#### TOWN OF PALM BEACH

PLANNING, ZONING, & BUILDING DEPARTMENT
PZ&B Staff Combination Memorandum: Architectural Commission and Town Council

SUBJECT: ARC-24-0108 (ZON-24-0066) 1519 N OCEAN WAY (COMBO)

MEETING: JANUARY 29, 2025 ARCOM

Snippet of property survey.

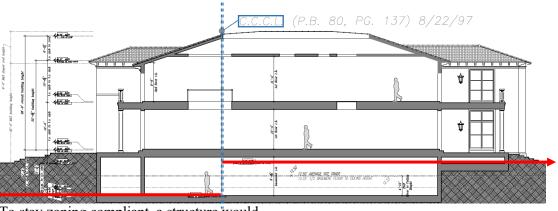
The Special Exception stems from the existing configuration of the lot. The town's zoning code requires a minimum lot width of 125' in the R-A zoning district, with the existing parcel only providing 89.9'. Although nonconforming, the code does permit the redevelopment of existing nonconforming parcels in the R-A through the special exception process (in lieu of a variance).

<b>Code Section</b>	Required	Existing	Deficiency
Special Exception: Sec. 134-843(b)	Minimum Lot Width of 125'	Lot Width of 89.9'	- 35.1'

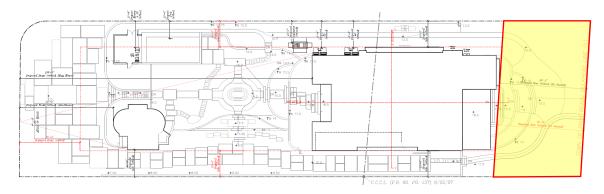
Two of the variances requested have to do with the Coastal Construction Control Line (CCCL) that bifurcates the property. The town's definition of building height was updated and due to the changes, this property would have two separate points of measurement. Having the separate points of measurement protects the neighborhood by accounting for the change in lot grade and topography as the property moves westward, away from the ocean. On this parcel, one point of measurement is for portions of the building at and east of the CCCL, and the other is for buildings or portions of buildings west of the CCCL. A building that crosses the CCCL would have two separate points of measurement.

To stay zoning compliant, a structure would "step down" as it crosses west over the CCCL, reducing the height and mass as the grade elevation decreases. In this case, the applicant's desire is to have a single plane for the basement, first and second floors, without stepping down. The point of measurement at and east of the CCCL is 15.9' NAVD, and 7.55' NAVD west of the CCCL. The majority of the main structure is at or east of the CCCL, however, a small porition at the front of the main structure is west of the CCCL, which has a lower point of measurement. Therefore, two variances are being requested to exceed maximum

building height and maximum overall building height for the portion of the main structure west of the CCCL.

<b>Code Section</b>	Section Permitted Proposed		Variance
<u>VARIANCE 1:</u> Sec. 134-843(10)a.	Max. Building Height of 25'	Building Height 30.96'	+ 5.96'
<u>VARIANCE 2:</u> Sec. 134-843(10)b.	Max. Overall Building Height of 35'	Building Height 37.15'	+ 2.15'
